Declaration letter

Model No.: Deco XE75, Deco XE5300, Deco XE75 Pro

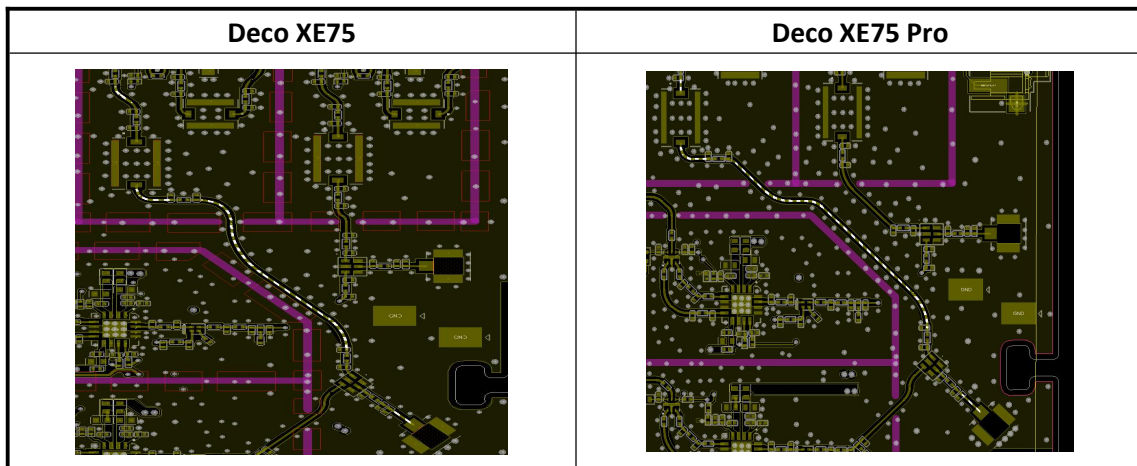
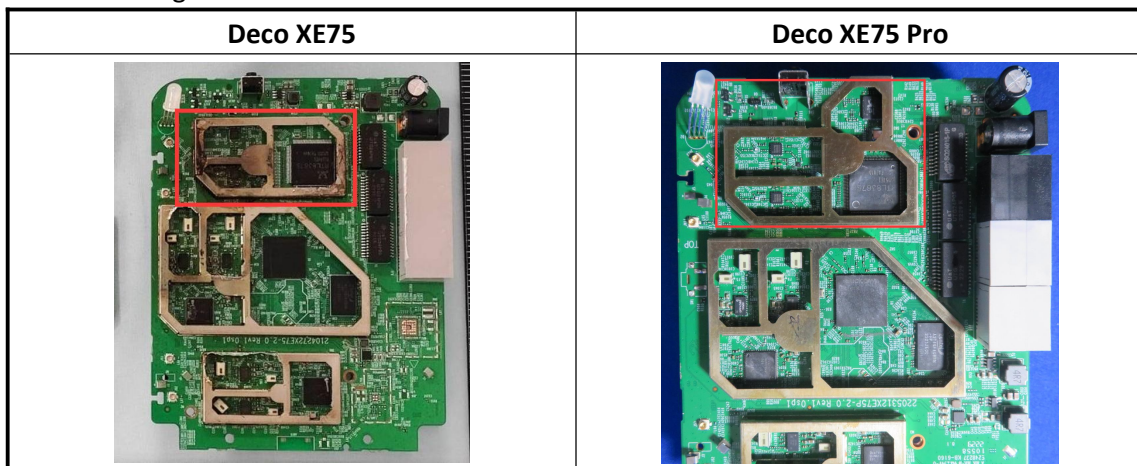
The difference between Deco XE75 Pro and Deco XE75 & Deco XE5300 as follows:

1. Ethernet chip is changed.
2. The color and size of RJ45 connector is different.
3. Wi-Fi 5G RF trace is moved.

4. Shielding case of Wi-Fi 2G is different.
